APPENDIX C5: COMMENTS & RESPONSES RECEIVED

- 5.1. Initial Notification**
- 5.2. Draft Amendment Phase**

From: Ashleigh Blackwell <ashleighb@arcusconsulting.co.za>
Sent: Friday, July 31, 2020 10:08
To: EIA Applications <EIAApplications@environment.gov.za>
Subject: Request for a Pre-Application Meeting for 2 Amendments and a Basic Assessment for the Paulputs WEF

authorisation for the Paulputs Wind Energy Facility (WEF) on 11 December 2019, DEFF Reference No. 14/12/16/3/3/2/1160.

Figure 2. Satellite image map of the project layout.

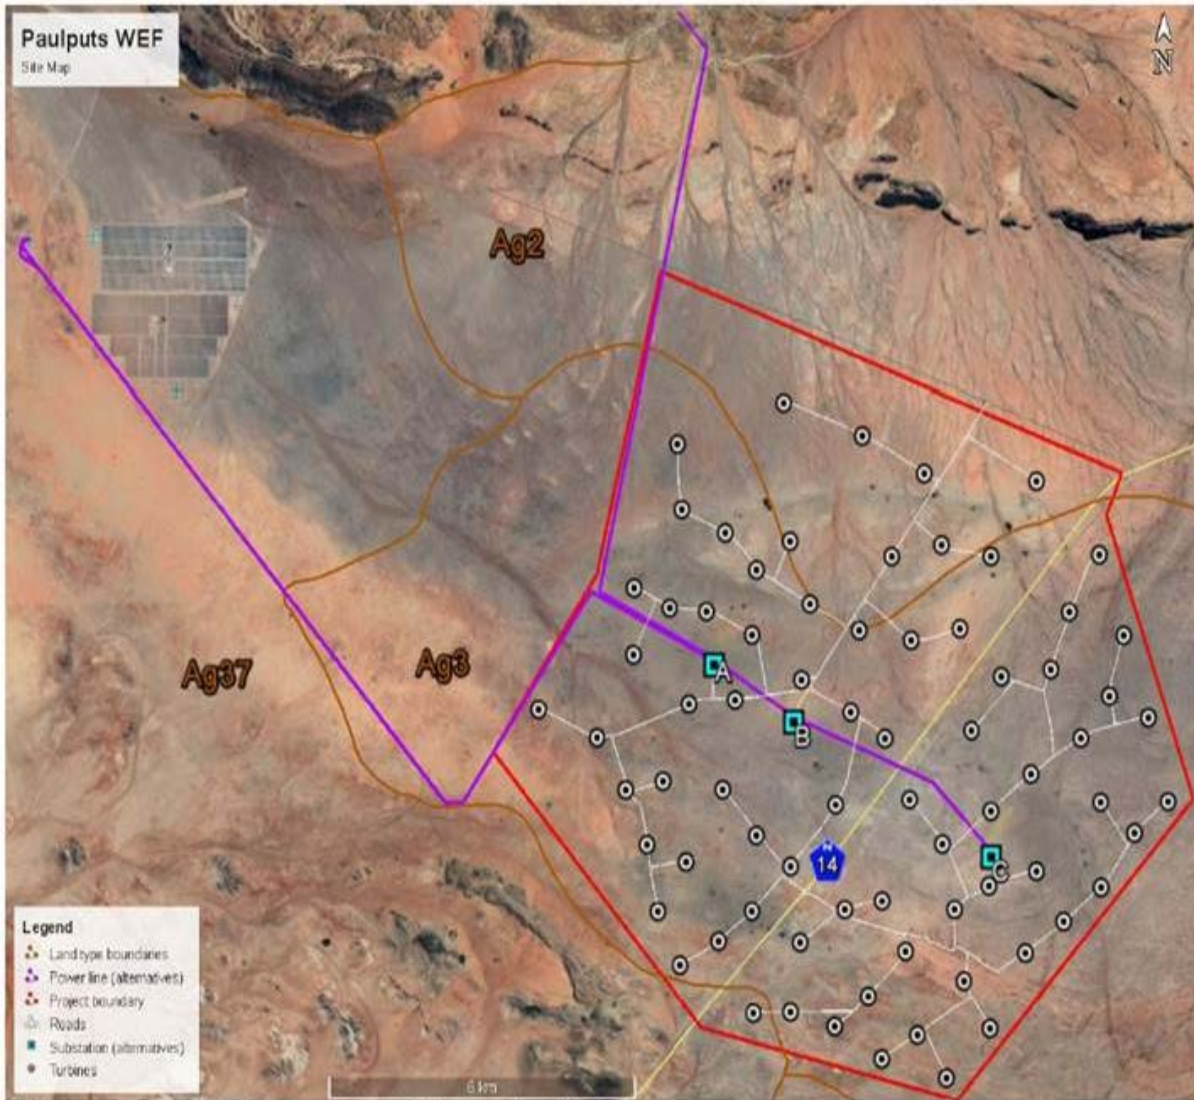
I am enquiring about the proposed Paulputs wind farm, our project is located in the North West corner of the map below.

We would like some information about the status of the project and planned commencement dates, we are planning some works at a high level for late 2021 and 2022 would like to know if the proposed project can potentially impact our planning regarding:
